Value Engineering Study

**Cousins Pumping Station Complex
Jefferson Parish, Louisiana**

**U.S. Army Corps of Engineers
New Orleans District**

SUBJECT: Value Engineering (VE) Study for the West Bank,
Vicinity of New Orleans, LA Hurricane Protection Project -
Cousins Pump Station Complex

IDENTIFICATION NUMBER: V.E-8

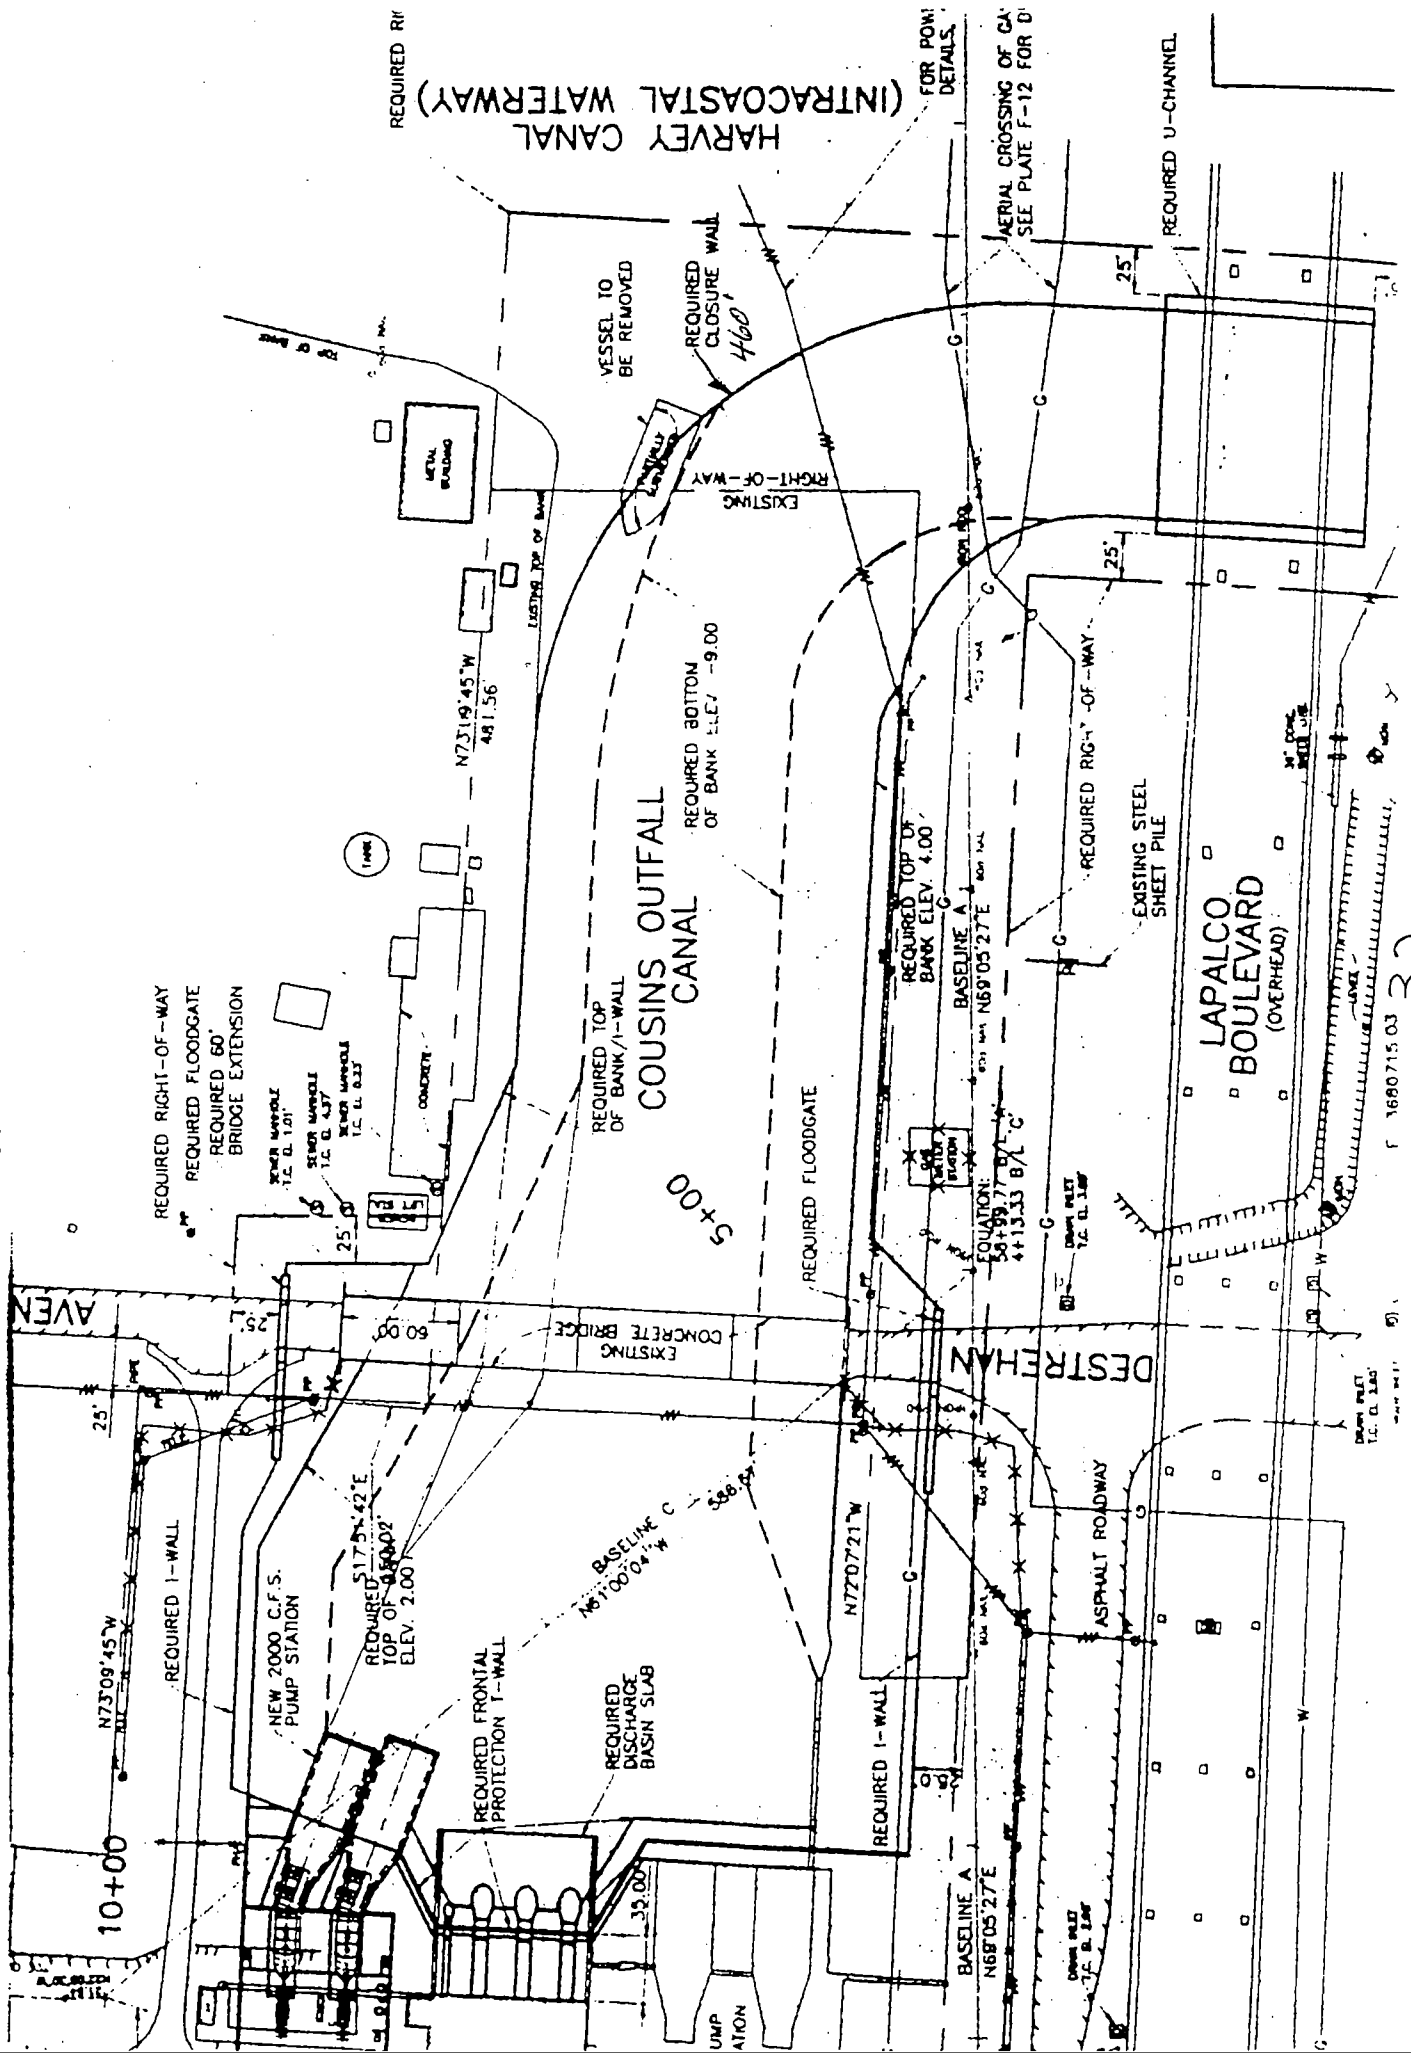
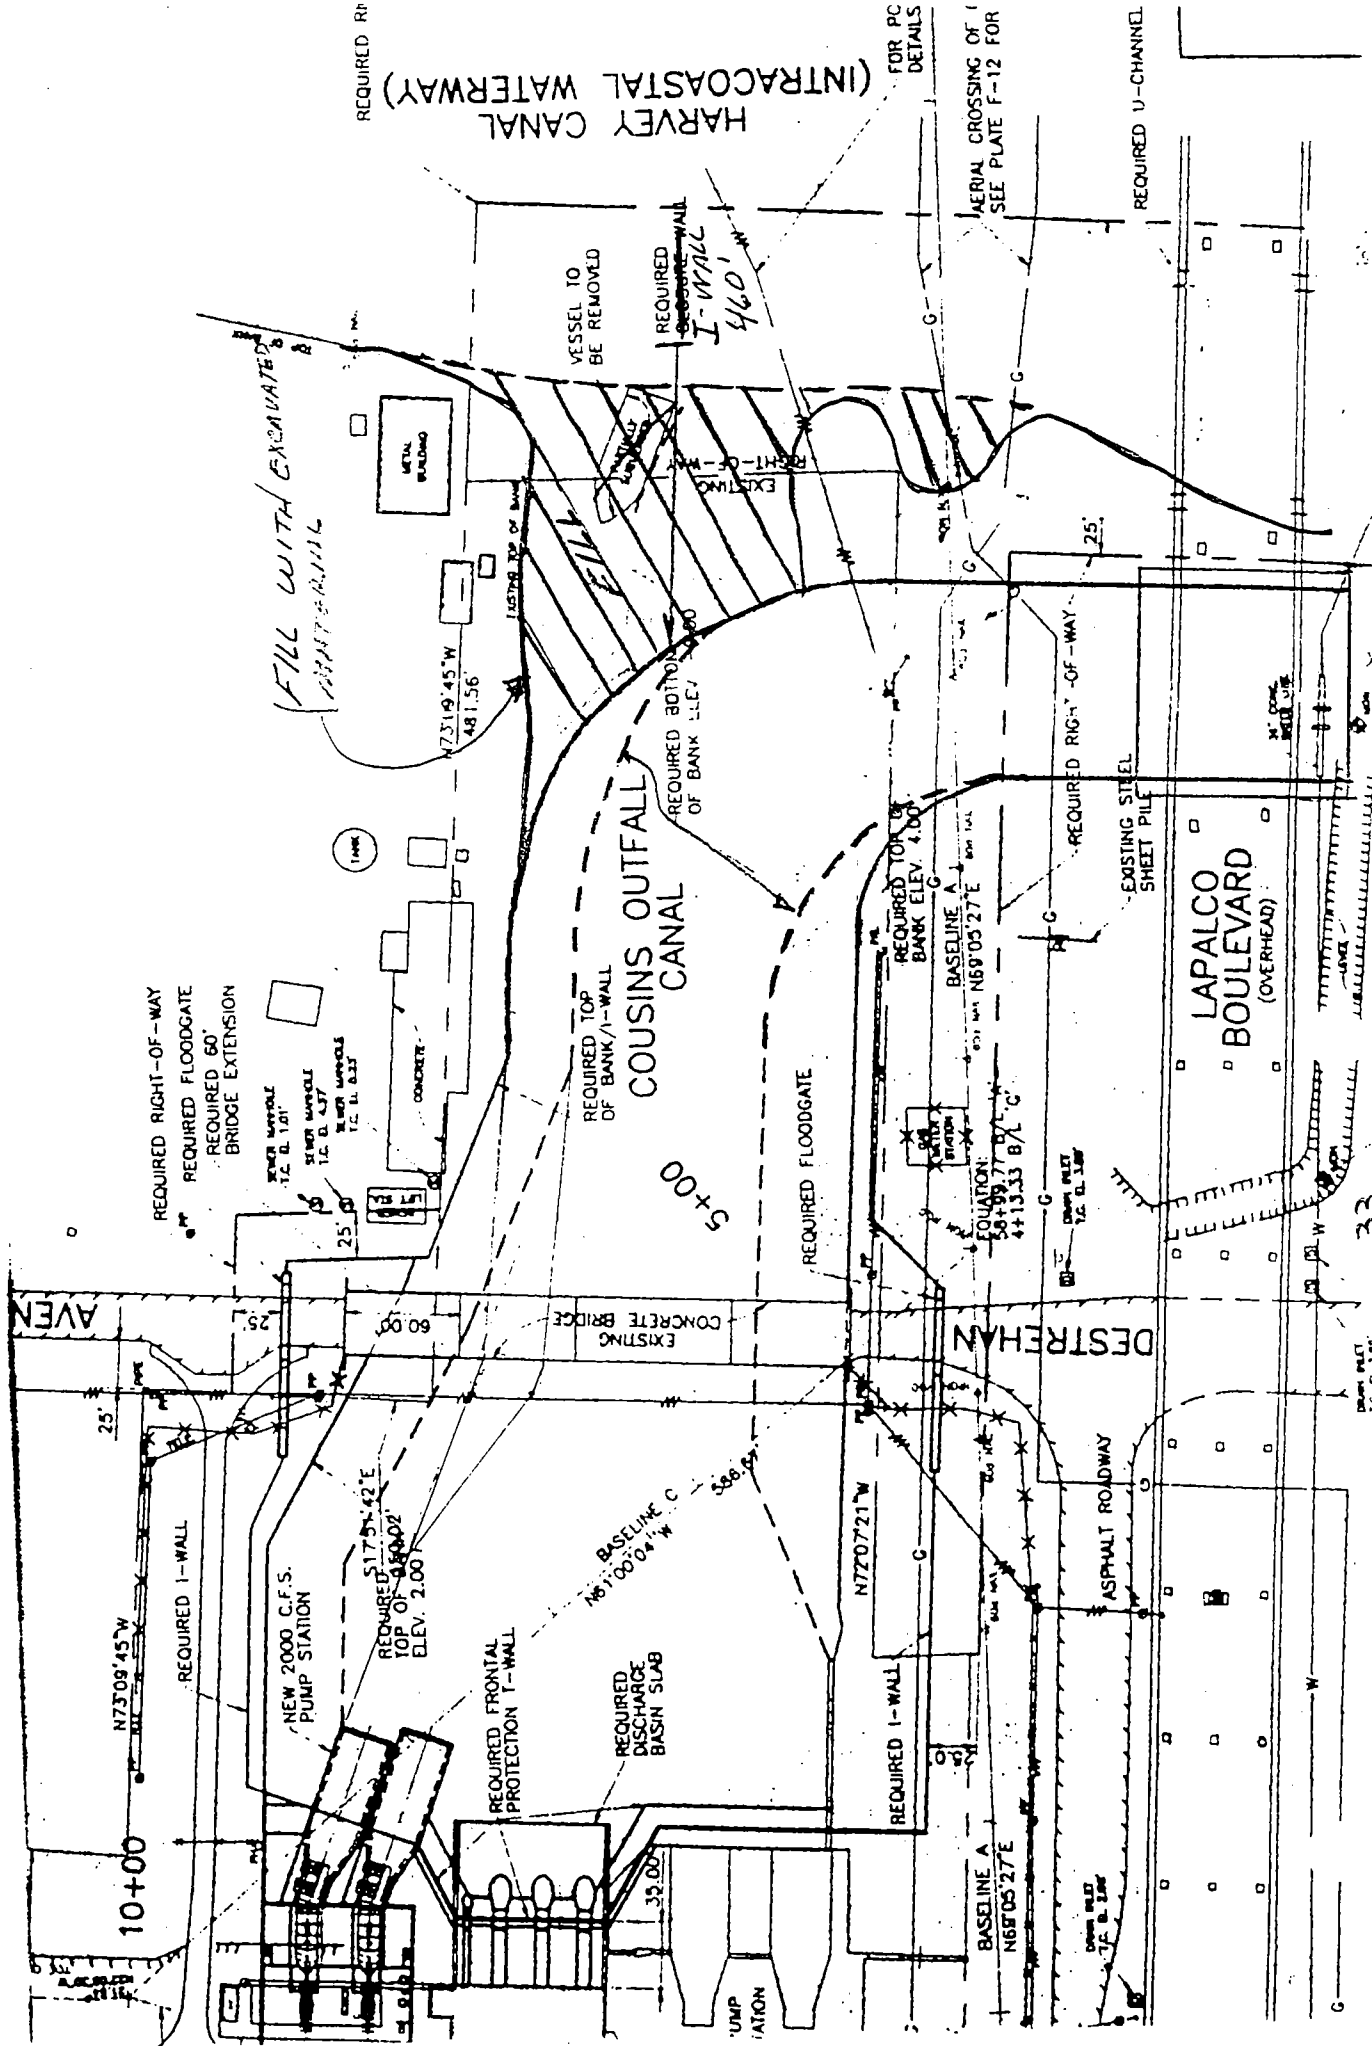
Relocate discharge canal under Lapalco bridge one bay to the west. Replace the pipe/sheetpile closure wall with a sheetpile I-wall.

Far more important, however, is that this design change takes the flood protection out of harm's way in the heavily traveled Harvey Canal. The potential consequences of an untimely collision, breaching this flood barrier are enormous and should be avoided.
